**COUNTY OF SACRAMENTO  
CALIFORNIA**

**PLANNING COMMISSION REPORT**

Subject: PLNP2016-00076. Vong Residential Accessory Dwelling. Request For A Use Permit For A Property Located At 8200 Daisy Hill Drive, Approximately 500 Feet South Of Wildhawk Drive, In The Vineyard Community. Applicant: Huy Vo. APN.: 122-0470-001. Environmental Determination: Exempt

**ELEVATIONS**

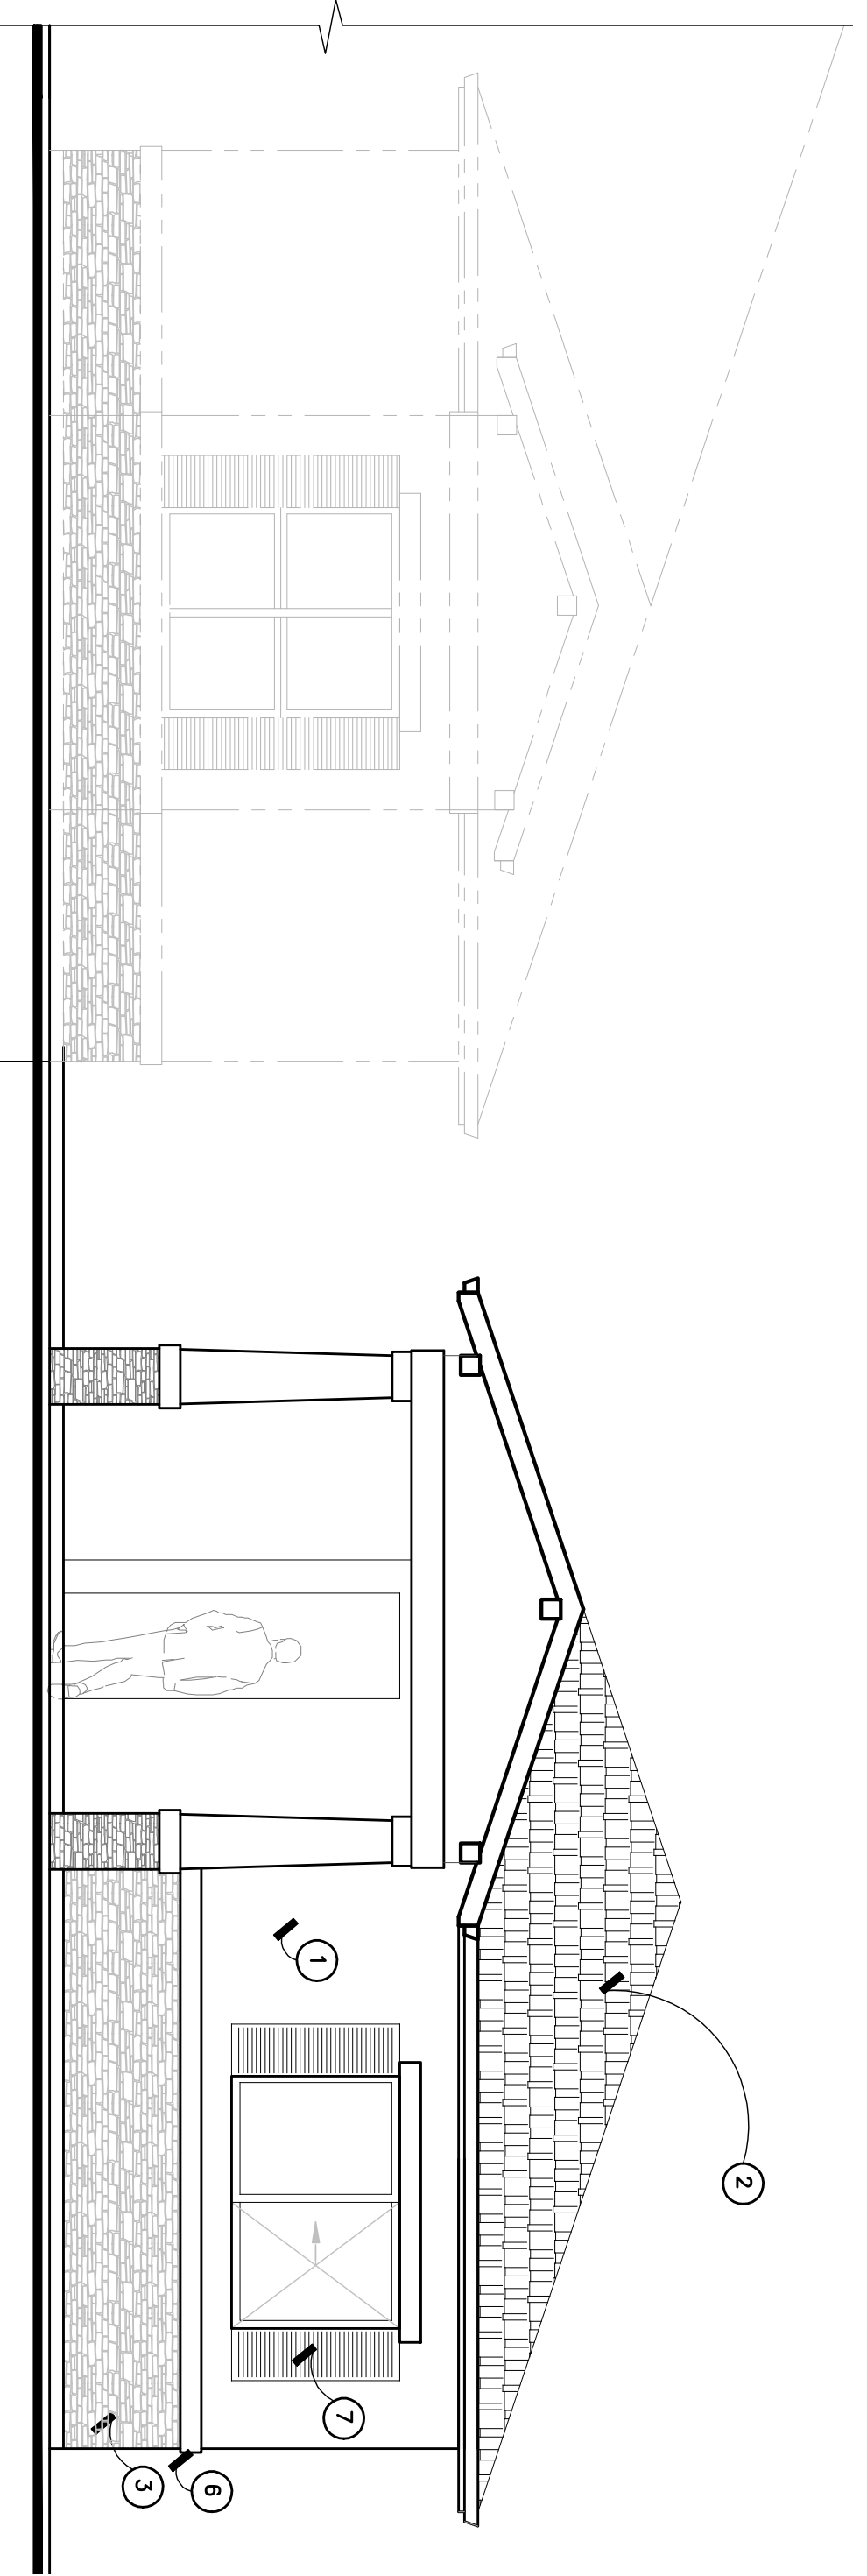
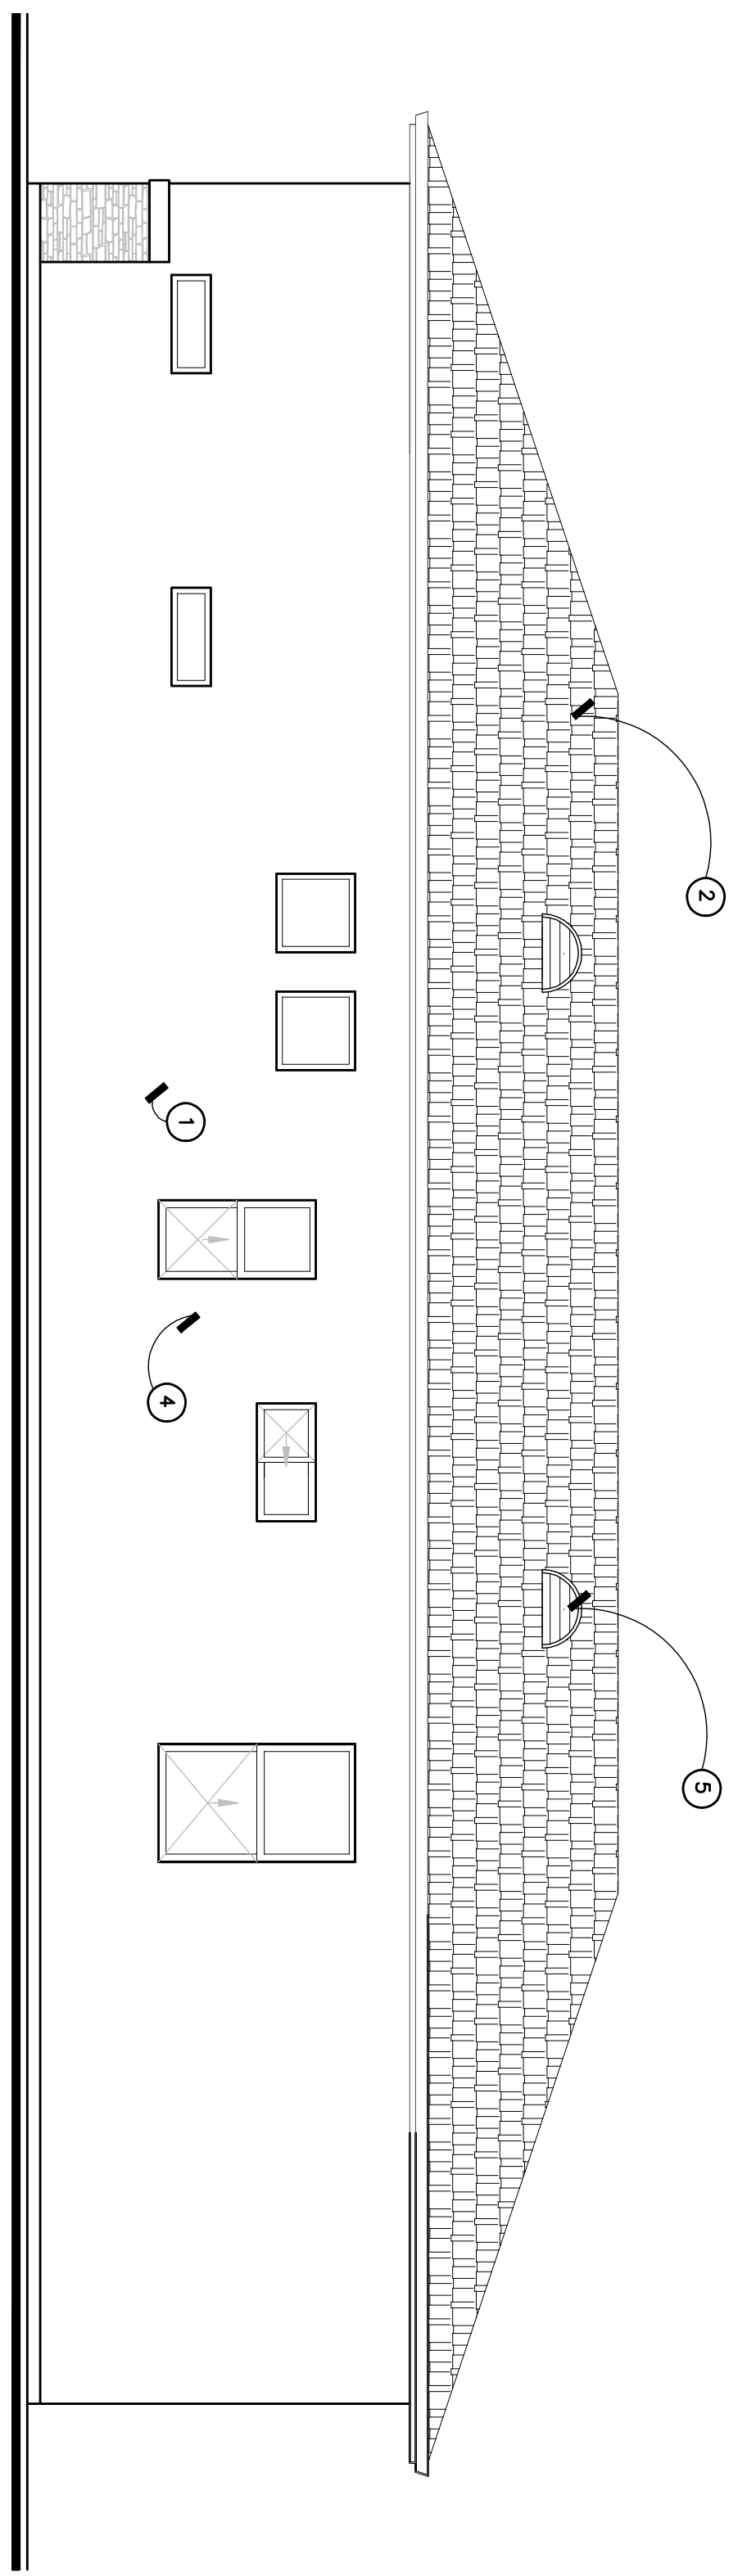
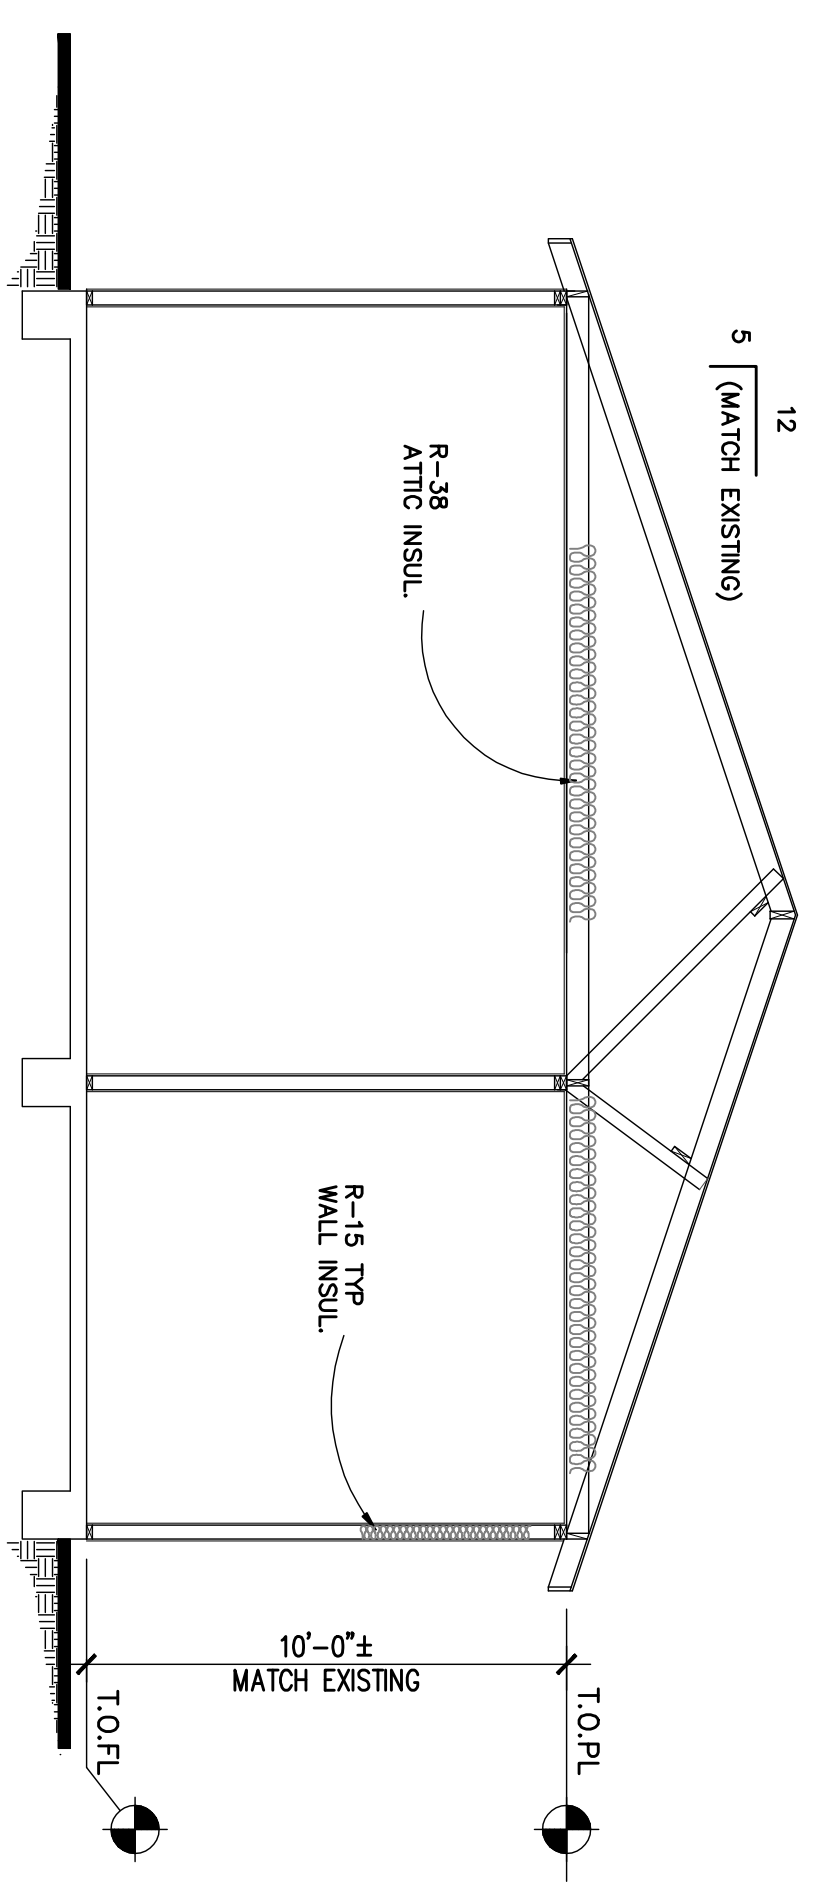
8. Privacy Impact. In addition to no greenery screen, the elevation drawings show five windows on the south side of the new building right over the fence within 5 feet of my rear property line. Individuals with one-acre lots expect more backyard privacy than this. There is no easy way that I could screen those windows from viewing my yard and my pool without building a higher fence or having to remove my solar panels to replace it with a greenery screen. This is an expense that I would prefer not to have and I certainly do not want to eliminate my pool solar panels.
